Product Change Notification / NTDO-17SDDT634

CCB 4529 Final Notice: Qualification of MTAI as an additional assembly site for selected AT86RF215, ATmega644/1284/2564RFR2 and ATSAM4Lx8xx device families available in 48L VQFN (7x7x0.9mm) package.

PCN #: NTDO-17SDDT634

Lead frame Comparison

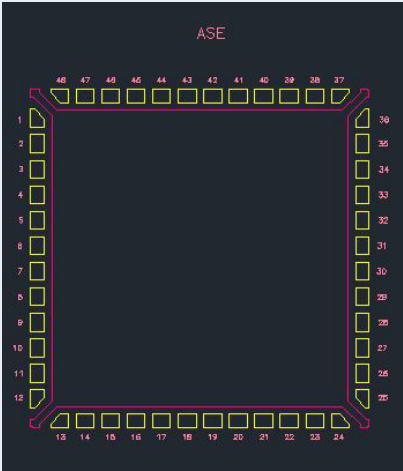
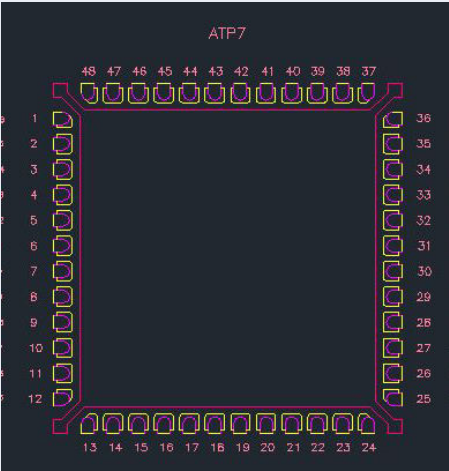
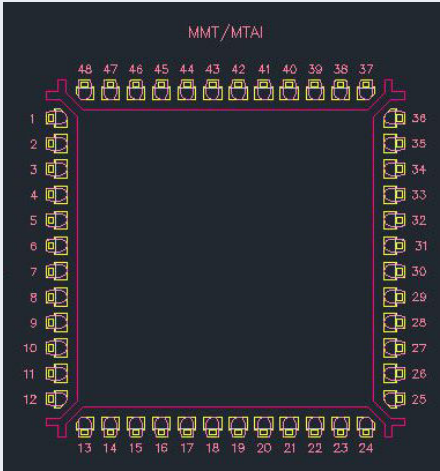
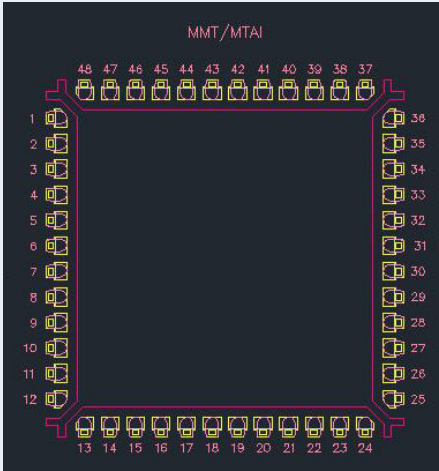
Pre Change			Post Change
ASE	ATP7	MMT	MTAI
 <p>Diagram of the ASE lead frame. It is a square frame with pins numbered 1 through 48. The top edge has pins 48, 47, 46, 45, 44, 43, 42, 41, 40, 39, 38, 37. The right edge has pins 36, 35, 34, 33, 32, 31, 30, 29, 28, 27, 26, 25. The bottom edge has pins 24, 23, 22, 21, 20, 19, 18, 17, 16, 15, 14, 13. The left edge has pins 12, 11, 10, 9, 8, 7, 6, 5, 4, 3, 2, 1.</p>	 <p>Diagram of the ATP7 lead frame. It is a square frame with pins numbered 1 through 48. The top edge has pins 48, 47, 46, 45, 44, 43, 42, 41, 40, 39, 38, 37. The right edge has pins 36, 35, 34, 33, 32, 31, 30, 29, 28, 27, 26, 25. The bottom edge has pins 24, 23, 22, 21, 20, 19, 18, 17, 16, 15, 14, 13. The left edge has pins 12, 11, 10, 9, 8, 7, 6, 5, 4, 3, 2, 1.</p>	 <p>Diagram of the MMT/MTAI lead frame. It is a square frame with pins numbered 1 through 48. The top edge has pins 48, 47, 46, 45, 44, 43, 42, 41, 40, 39, 38, 37. The right edge has pins 36, 35, 34, 33, 32, 31, 30, 29, 28, 27, 26, 25. The bottom edge has pins 24, 23, 22, 21, 20, 19, 18, 17, 16, 15, 14, 13. The left edge has pins 12, 11, 10, 9, 8, 7, 6, 5, 4, 3, 2, 1.</p>	 <p>Diagram of the MTAI lead frame. It is a square frame with pins numbered 1 through 48. The top edge has pins 48, 47, 46, 45, 44, 43, 42, 41, 40, 39, 38, 37. The right edge has pins 36, 35, 34, 33, 32, 31, 30, 29, 28, 27, 26, 25. The bottom edge has pins 24, 23, 22, 21, 20, 19, 18, 17, 16, 15, 14, 13. The left edge has pins 12, 11, 10, 9, 8, 7, 6, 5, 4, 3, 2, 1.</p>

<div><div>Lead frame material</div><div>C194</div></div> <div><div>Lead frame DAP surface prep</div><div>Ag Ring plating</div></div> <div><div>Lead frame lead-lock</div><div>No</div></div>	<div><div>Lead frame material</div><div>C194</div></div> <div><div>Lead frame DAP surface prep</div><div>Bare Cu</div></div> <div><div>Lead frame lead-lock</div><div>No</div></div>	<div><div>Lead frame material</div><div>C194</div></div> <div><div>Lead frame DAP surface prep</div><div>Bare Cu</div></div> <div><div>Lead frame lead-lock</div><div>Yes</div></div>	<div><div>Lead frame material</div><div>C194</div></div> <div><div>Lead frame DAP surface prep</div><div>Bare Cu</div></div> <div><div>Lead frame lead-lock</div><div>Yes</div></div>

Note: The lead lock hole fills with mold compound during the assembly process and provides improved protection against moisture penetration around the interface edges between pins and mold compound.
